**ADMINISTRATIVE INFORMATION****FMI No: 22901****FMI Title: NGPDU SOFT-START RESISTOR REPLACEMENT**

FMI No.: 22901 FMI Title: NGPDU SOFT-START RESISTOR REPLACEMENT

Figure 2 - New Resistor Assy

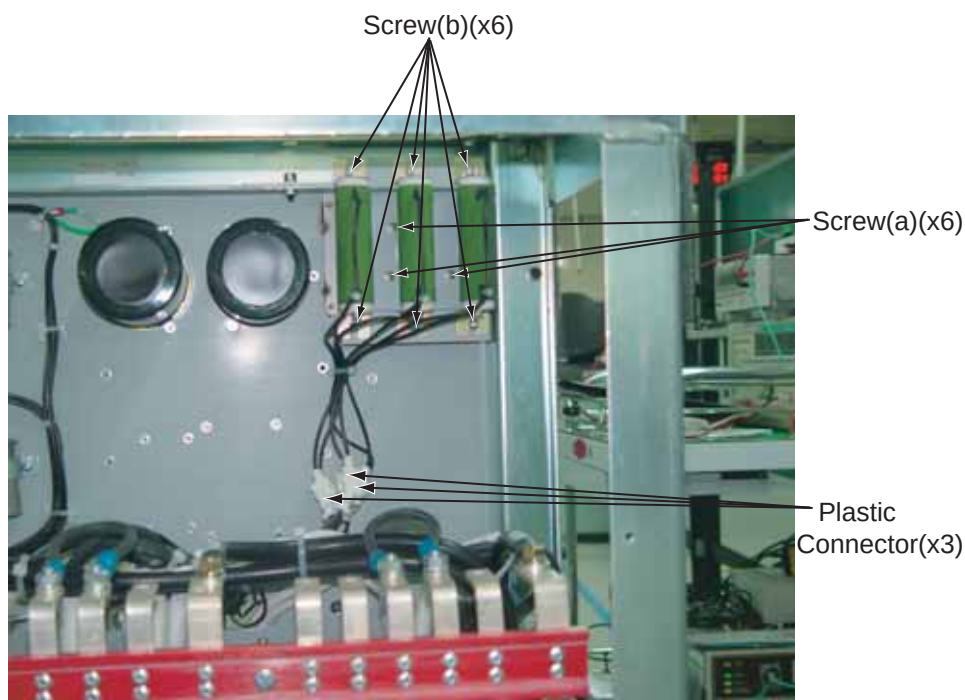
- 1.) Disassembly the old Resistor Assy (P/N: 2351496).
 - a.) Mark and disconnect the three plastic connectors.
 - b.) Unscrew the six screws.
 - c.) Remove the whole old Resistor Assy.

- 2.) Install the new Resistor Assy (P/N: 2391041) to the NGPDU.
 - a.) Fix the Resistor Assy with the six old screws(a).
In order to facilitate the installation, loosen the screws(b) at the two ends of the three green resistors.
 - b.) Connect the three plastic connectors with their counterparts.
